Technical Service Bulletin Number

TSB160118

New Exhaust Manifold

Table 2, New Exhaust Manifold.

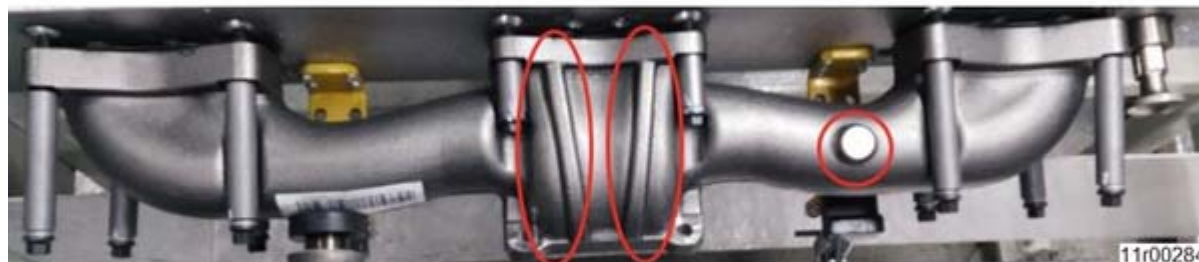
This document informs the field of a new exhaust manifold part number. The new exhaust manifold has been redesigned and is thicker to make the exhaust manifold more robust.

New exhaust manifold part number **must** be used if replacing exhaust manifold on an ISG12 CM2880 G107 or ISG12 CM2880 G109.
